Access Compliance Report

Public Rights-of-Way

(Curb Ramps)

Intersection ID: 3628	Main Street: DICKSON_LN	Cross Street: MAYCROFT_DR	Location: E
ADA ID: CDFFAA5F8388	Ramp Type: Perp	Initial Pass/Fail: Fail	Overall Compliance: No
Severity Score: 33.75			
Codes/Mitigation Info/Possible Solution		Field Measurements/Component Compliance

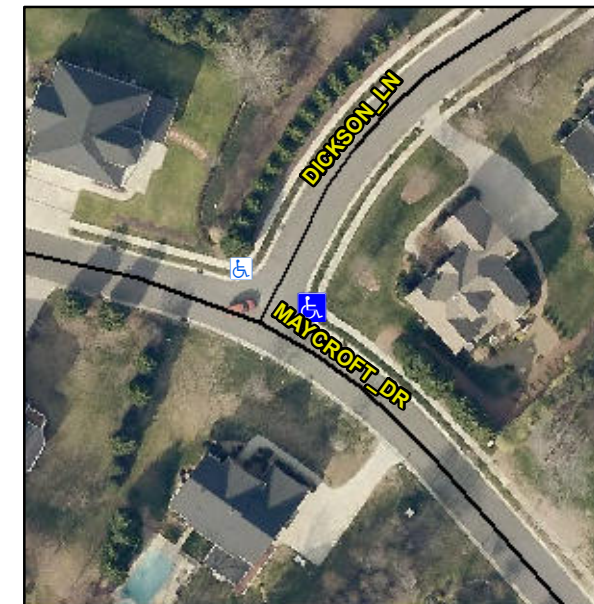
Not Found, R304.5.1, R304.5.3

Compliance	Description	Data	Compliance	Description	Data
N/A	Ramp Length (in)	49.0	Yes	Ramp Slope (%)	7.0
No	Ramp Width (in)	42.0	No	Ramp XSlope (%)	12.7
N/A	Flare Type LT	N/A	N/A	Flare Type RT	N/A
N/A	Flare Slope LT (%)	N/A	N/A	Flare Slope RT (%)	N/A
N/A	Flare Traversable LT?	N/A	N/A	Flare Traversable RT?	N/A
N/A	Landing Length (in)	N/A	N/A	DWS Provided?	N/A
N/A	Landing Width (in)	N/A	N/A	DWS Contrast?	N/A
N/A	Landing Slope (%)	N/A	N/A	DWS Length (in)	N/A
N/A	Landing X Slope (%)	N/A	N/A	DWS Full Width?	N/A
N/A	Landing Curb? (Y/N)	N/A	N/A	DWS Offset (in)	N/A
N/A	Shared Landing?	N/A			
N/A	Gutter Ponding?	N/A	N/A	Gutter Slope (%)	N/A
N/A	Gutter Lip Ht (in)	N/A	N/A	Gutter X Slope (%)	N/A
N/A	Painted X Walk1?	No	N/A	Painted X Walk2?	N/A
	X Walk 1 Direction	To NW		X Walk 2 Direction	N/A
N/A	X Walk 1 Width (in)	N/A	N/A	X Walk 2 Width (in)	N/A
	X Walk 1 Slope (%)	4.3		X Walk 2 Slope (%)	N/A
	X Walk 1 X Slope (%)	7.4		X Walk 2 X Slope (%)	N/A

Remove & Replace Entire Ramp.
